HARTZELL PROPELLER INC.

SERVICE LETTER

Improved installation of beta rod guide lug and snap ring on Seabee aircraft with reversing propeller

Hartzell Model HC-A3(X,V,MV)20-3L on Seabee applications.

Figure 1 - HC-A3(X,V,MV)20-3L Propeller with Modified Beta Rod Guide Lug and Snap Ring.

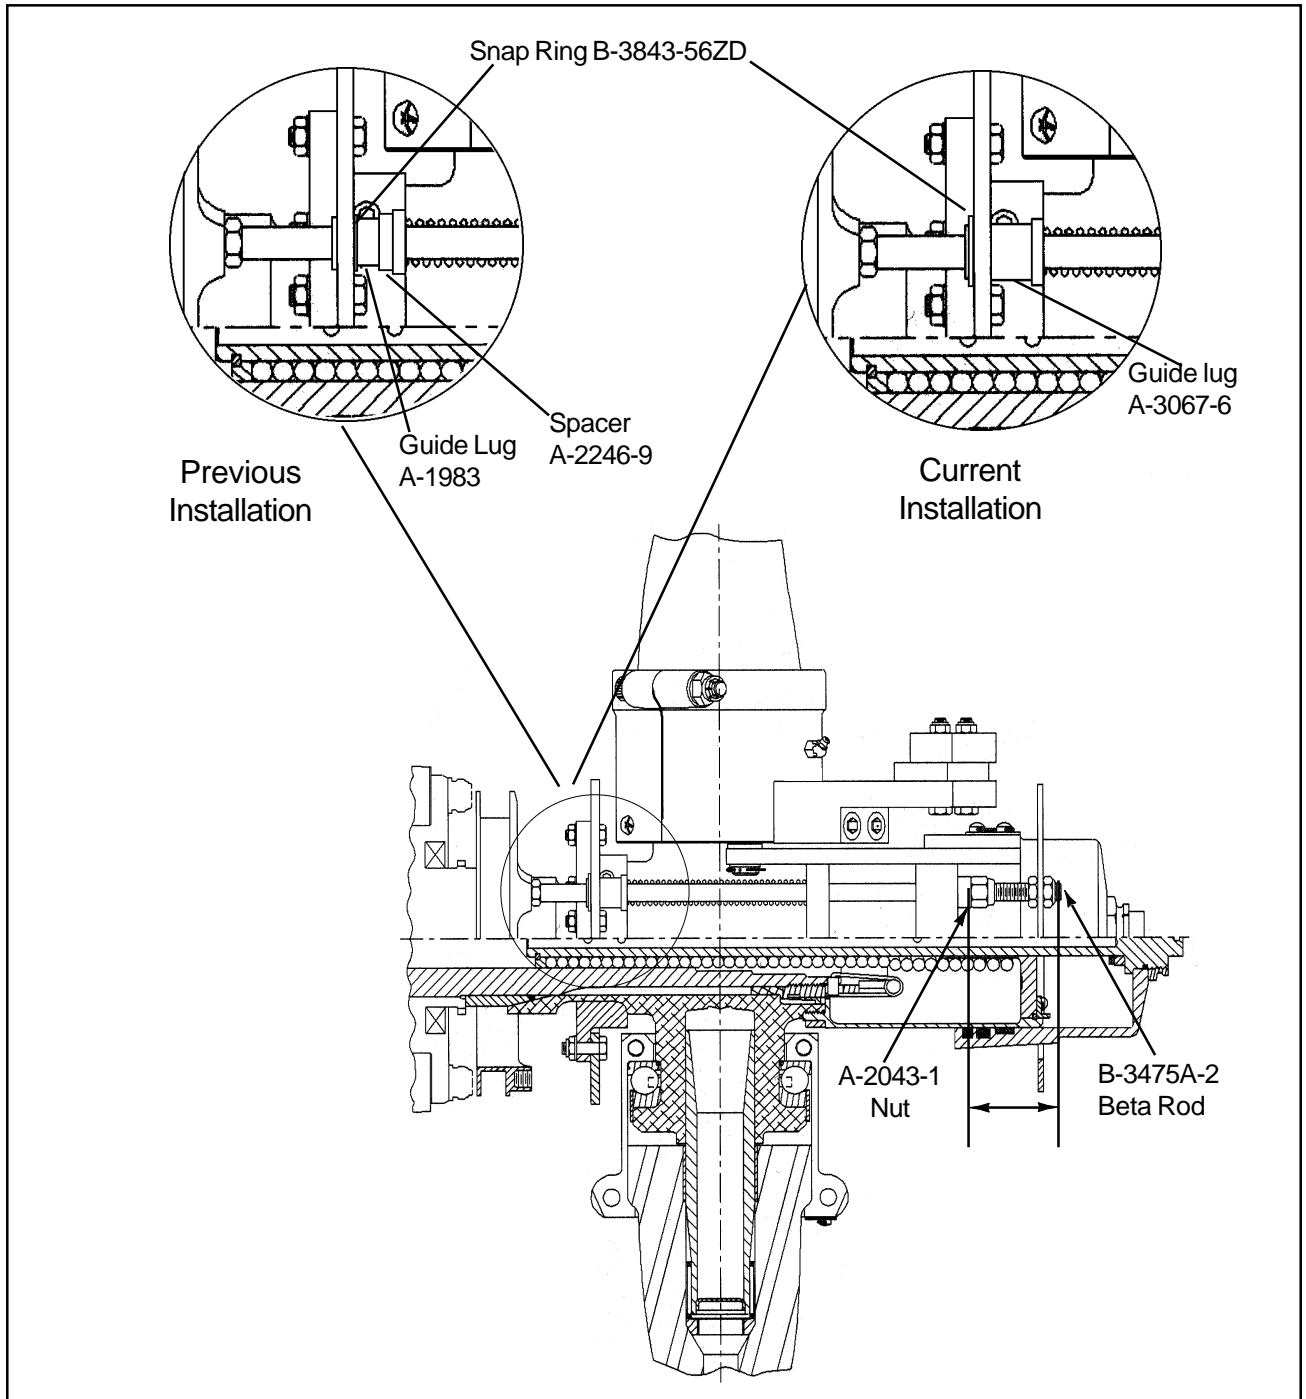
Problems have been encountered on reversing Seabee HC-A3(X,V,MV)20-3L propellers wherein the snap ring and guide lug came loose, damaging the beta ring.

Previously, the HC-A3(X,V,MV)20-3L propeller had an A-1983 guide lug and an A-2246-9 spacer installation that had the B-3843-56ZD snap ring carrying the load from the beta spring. This Service Letter authorizes the replacement of the above spacer and guide lug with an A-3067-6 guide lug. The A-3067-6 guide lug allows the spring force to be carried by the guide lug shoulder, allowing the snap ring to become a secondary, non load carrying, safety.

NOTE: Measure the distance from the bottom of each low pitch stop nut (A-2043-1) to the top of each beta rod (B-3475A-2) before disassembly. Record the measurement and location on top of the piston before disassembly (See Figure 1).

- (5) Disassemble the beta system in accordance with Hartzell Manual 114C (61-10-14).
 - (a) Discard the old guide lugs (A-1983) and spacers (A-2246-9). The new guide lug (A-3067-6) incorporates the guide lug and spacer into one unit (see Figure 1, Previous Installation).

- (1) Install the beta system in accordance with Hartzell Manual 114C (61-10-14).
 - (a) When installing the guide lugs (A-3067-6) in the support plate, the snap ring (B-3843-56ZD) must be placed on the engine side of the support plate (see Figure 1, Current Installation).
- (2) Install the cylinder and guide collar in accordance with Hartzell Manual 114C (61-10-14).
- (3) Install the propeller on the aircraft in accordance with Hartzell Manuals 114C (61-10-14), 168 (61-00-68) and STC holder specifications.
- (4) Install the feathering spring assembly in accordance with Hartzell Manual 114C (61-10-14).
- (5) Install the piston assembly in accordance with Hartzell Manual 114C (61-10-14).
 - (a) Reassemble using previously recorded measurement to set propeller low pitch.
- (6) Make a record entry indicating compliance with this service letter.
